SUNDRAM LTD DBA BAYMONT INN & SUITES

Enclosed is the application for Administrative Review of the site 2601 Mulberry St SE. I'm requesting to replace the current chain link fence (6 feet height) with wrought iron fence with same height (6 feet). My request is based on the fact that chain link fence is hard to maintain with homeless people breaking into the property.

site plan!
 Administrative Amendment to replace chainlink fence with wrought iron fence 6' HEIGHT + 4" spacing on fence. Add ramp + sidewalk[#] miting on Noert entrance

RED ROOF INN
 AMENDED SITE PLAN FOR BUILDING PERMIT
 SHEET # 5 OF 9
 YVESIRA HWY, LLC
 8308 JEFFERSON RD
 ALBUQUERQUE, NEW MEXICO 87113
 505/968-3100
 JOB # 890304

ENGINEER'S SEAL	RED ROOF INN	DATE
	AMENDED SITE PLAN FOR BUILDING PERMIT	8/1/12
		2634542.DWG
		SHEET 7
		5 OF 9
		JOB # 890314

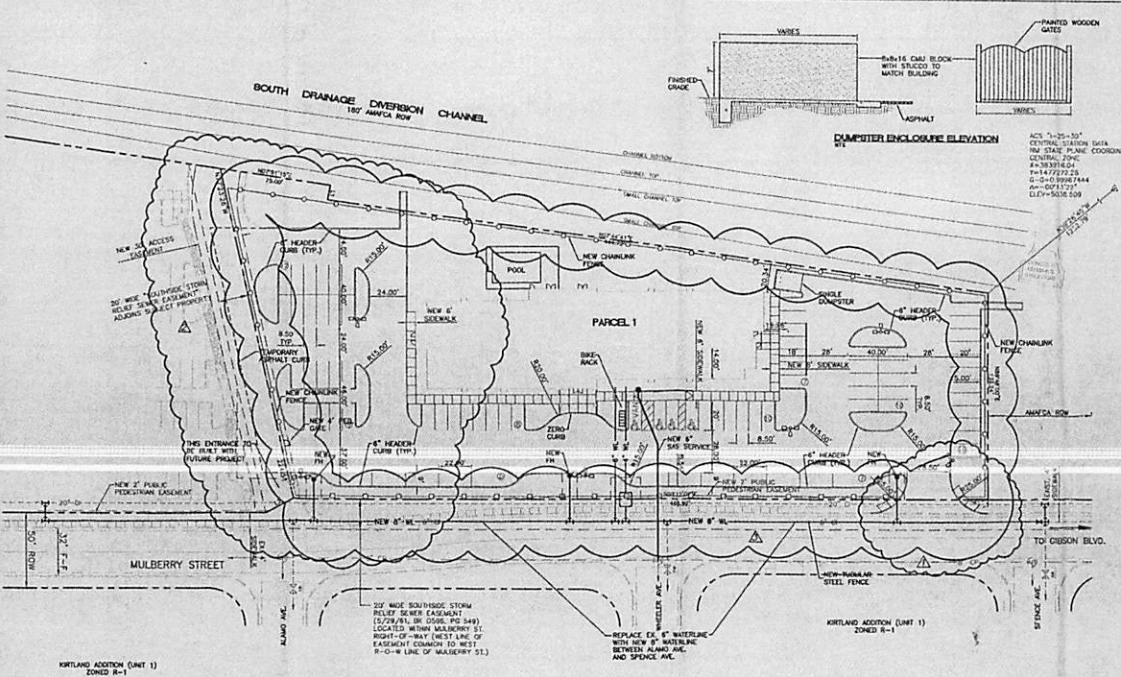
AREA / PROPERTY LINE MARKED WITH EXISTING CHAINLINK FENCE TO BE REPLACED WITH WROUGHT IRON FENCE 6' HEIGHT.

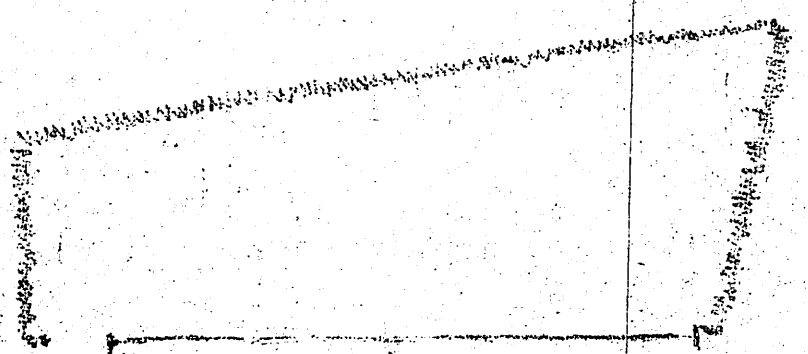
SIDEWALK per COA Std. Dwg. 2430 and RAMP per COA Std. Dwg. 2426, TIE TO EXISTING SIDEWALK.

WITH PROPOSED IRON FENCE & WINDMILL
 AFTER PROPOSED LINE WINDMILL WITH EXISTING CHAINLINK FENCE TO BE REMOVED

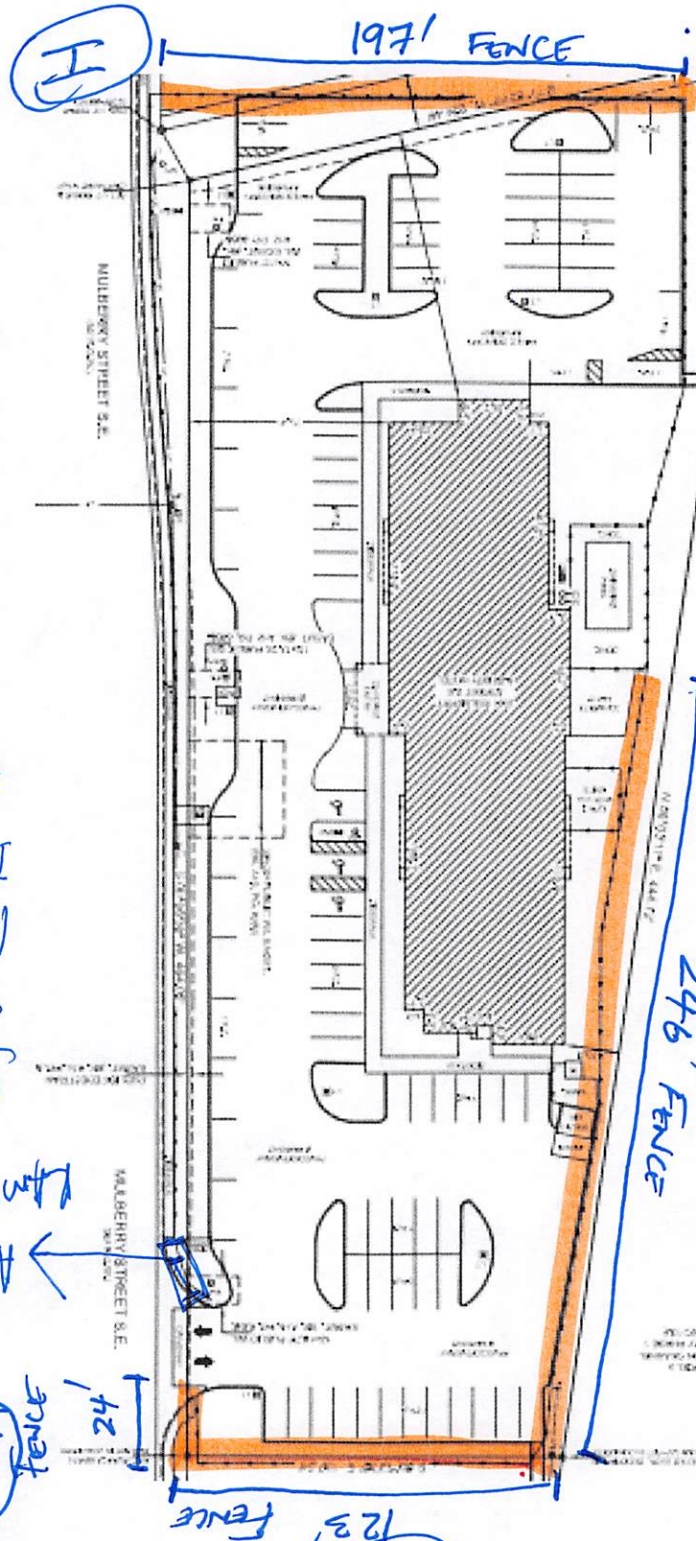
HIGHLIGHTED AREA IN ORANGE HAS EXISTING 6' CHAIN LINK FENCE + WILL BE REPLACED WITH 6' WROUGHT IRON FENCE WITH 4" SPACING.

EXISTING SIDEWALK.
 Dwg 2426, Tie To
 Ramp per COA Std.
 Std. Dwg 2430 and
 Sidewalk per COA

Ramp + Sidewalk 4'
 Add Unidirectional

6' HEIGHT ALL
 fence
